Access Compliance Report

Public Rights-of-Way

| Intersection ID: 29988 | Main Street: REIGATE_RD | Cross Street: BARVAS_ST | Location: E |
| ADA ID: 54FC9CDBC1DB | Ramp Type: PerpDiag | Initial Pass/Fail: Fail | Overall Compliance: No |

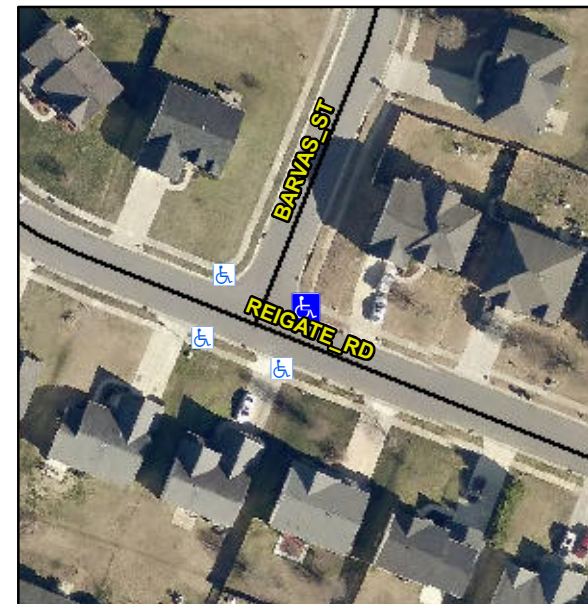
Not Found, R304.5.1, R304.5.3

| Compliance | Description | Data | Compliance | Description | Data |
|------------|-----------------------|-------|------------|-----------------------------|-------|
| No | Ramp Width (in) | 36.0 | No | Ramp XSlope (%) | 8.1 |

Remove & Replace Curb Ramp With Two New Directional Ramps or Equivalent.
